Common Report Problems	Following the CSM
	Sampling
	Tables & Figures
	Reporting

Phase 2 Blues (Notes From a Regulator)

John Fitzgerald, MassDEP

First Phase 2 Study – 1993

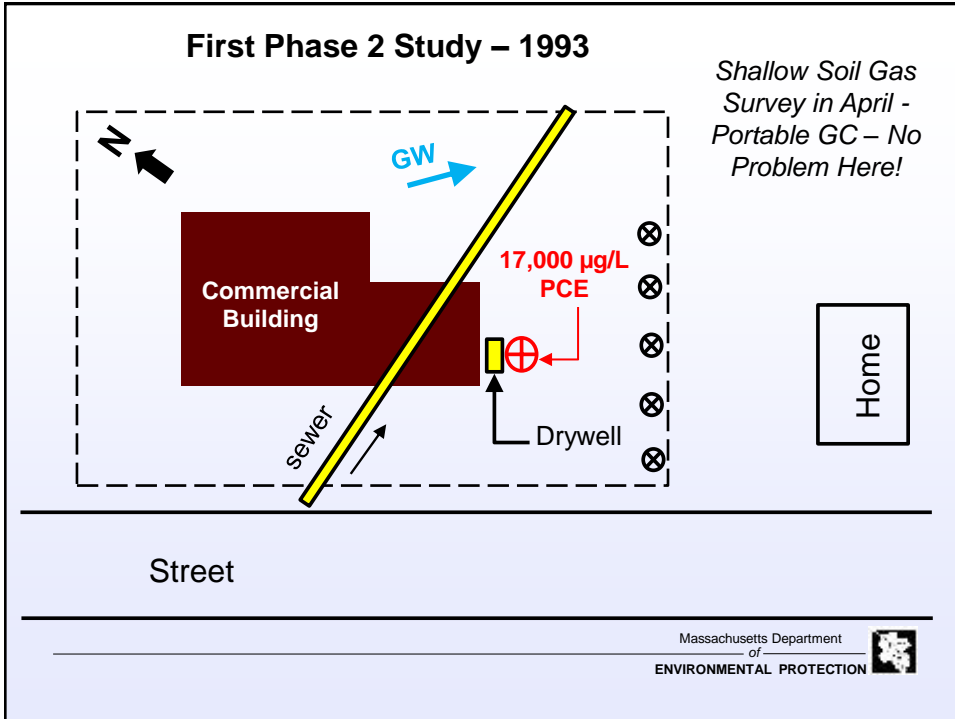
*DON'T DO THAT – PHASE II SHOULD BE
STAND ALONE!*

“The Phase II report did not meet the requirement to identify the source or to characterize the extent of the release and is therefore in violation of the MCP.”

Second Phase 2 Study – 2014

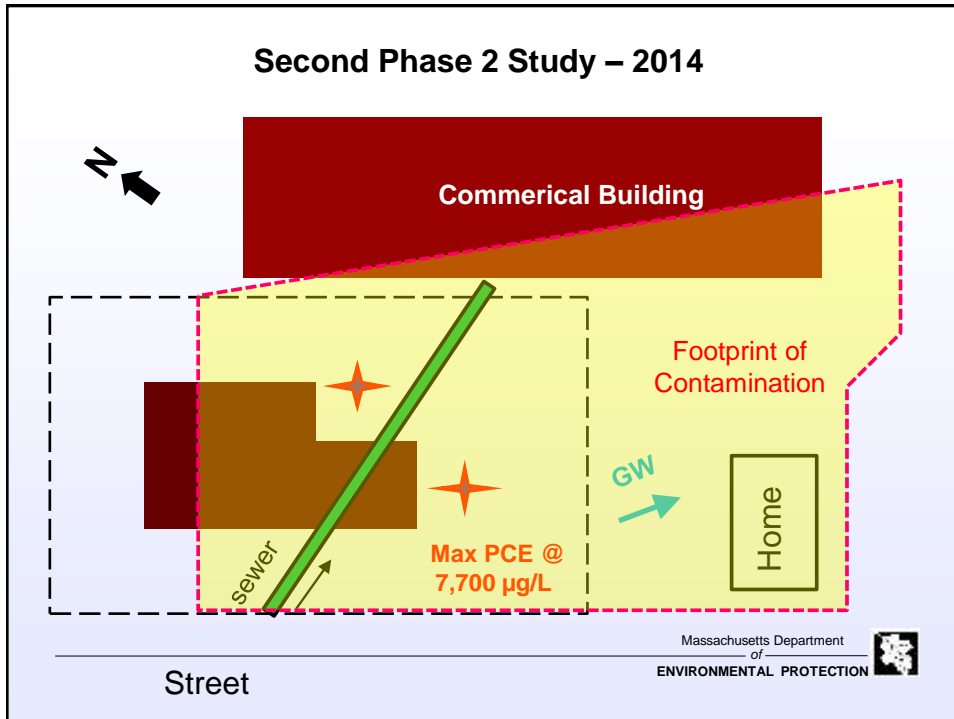
- *Need more off-property/deeper investigations*
- *Potential for sewer to act as preferred flow path must be further evaluated.*

(Phase 2)³ Report (2021)

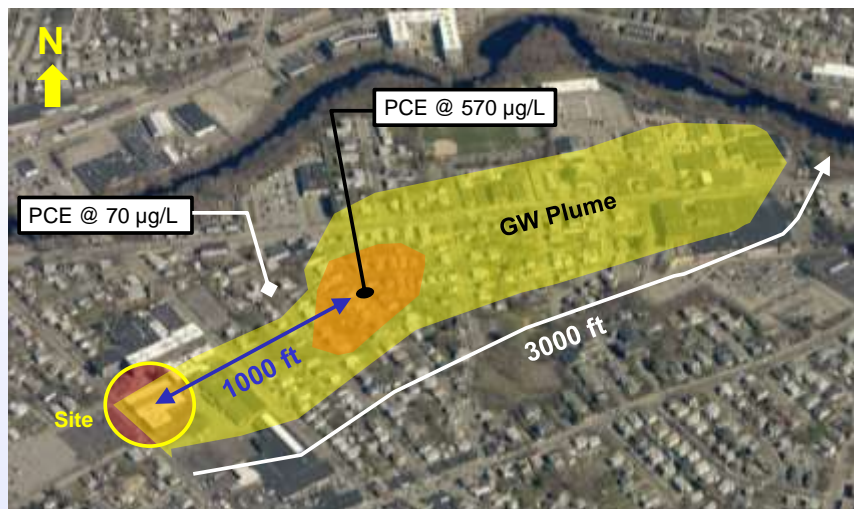
What's up with that Detached Plume, with the highest downgradient PCE concentration in groundwater 1000 feet from the site?

What's up with that “Orphan Plume” of 70 µg/L next to the site plume....

“Detached Plume” with highest gw contamination 1000 feet from release location? → Report CSM did not address

70 µg/L not from site? ↓

Likely a “surfacial release” at this location... BECAUSE...PCE is present in vadose zone @ 2-4 feet and 5-7 feet below ground surface.

Report CSM may be plausible EXCEPT THAT

Depth to GW only 4 – 5 feet below ground surface AND

Soil PCE concentrations values were wicked LOW (0.003 mg/kg) AND

Partitioning calculations show that a PCE groundwater concentration of 70 µg/L can partition to the vapor phase and then sorb onto vadose zone soils at levels well above 0.003 mg/kg PCE reported

Preferred Flow Path - Sewer

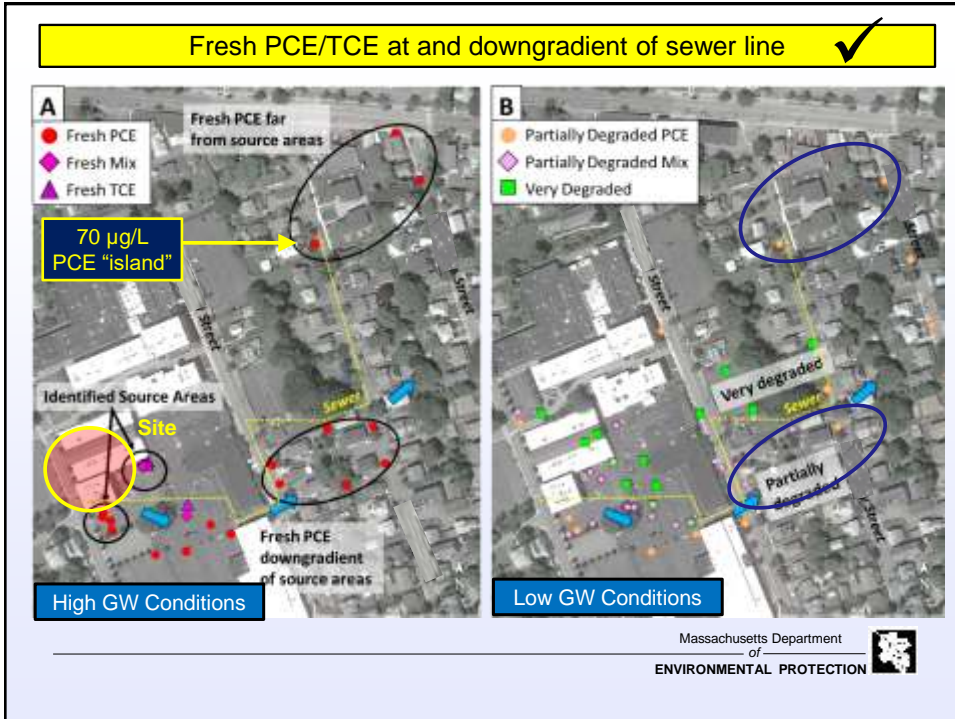
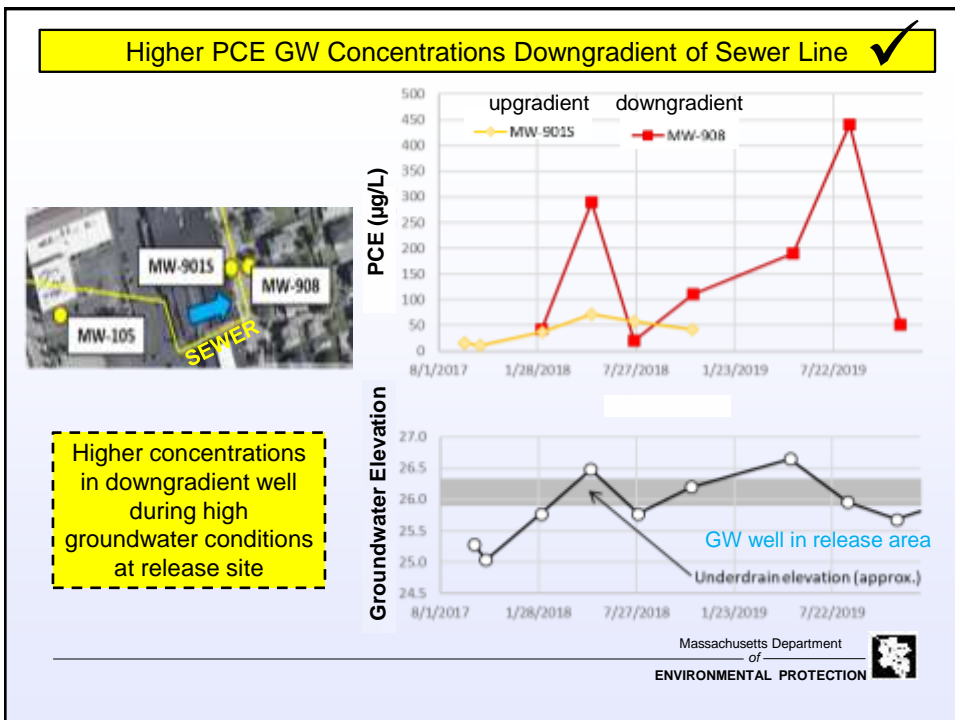
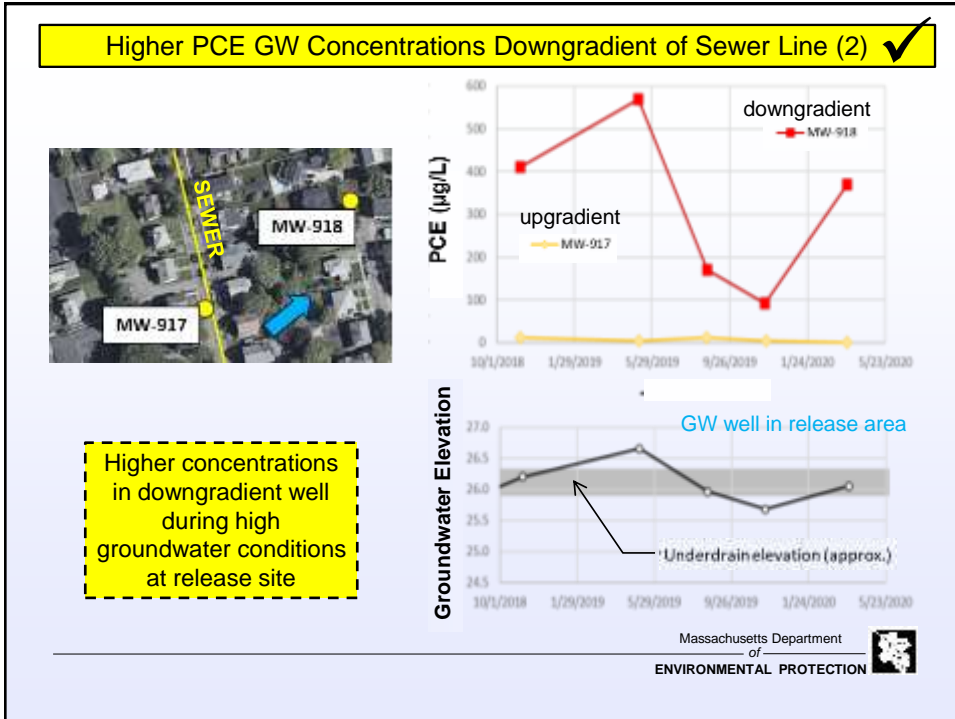
So, groundwater/contaminant transport in the sewer underdrain seems to explain....

- *The appearance of a “detached plume” and high/“fresh” conc of PCE 1000 ft downgradient*
- *The mystery origin of the 70 µg/L PCE “Island” (spoiler alert – the spills at the site in question)*

- *Obtain data to confirm or deny this CSM, e.g., locate and sample water in underdrain system*
- *Phase 2 take 4?*
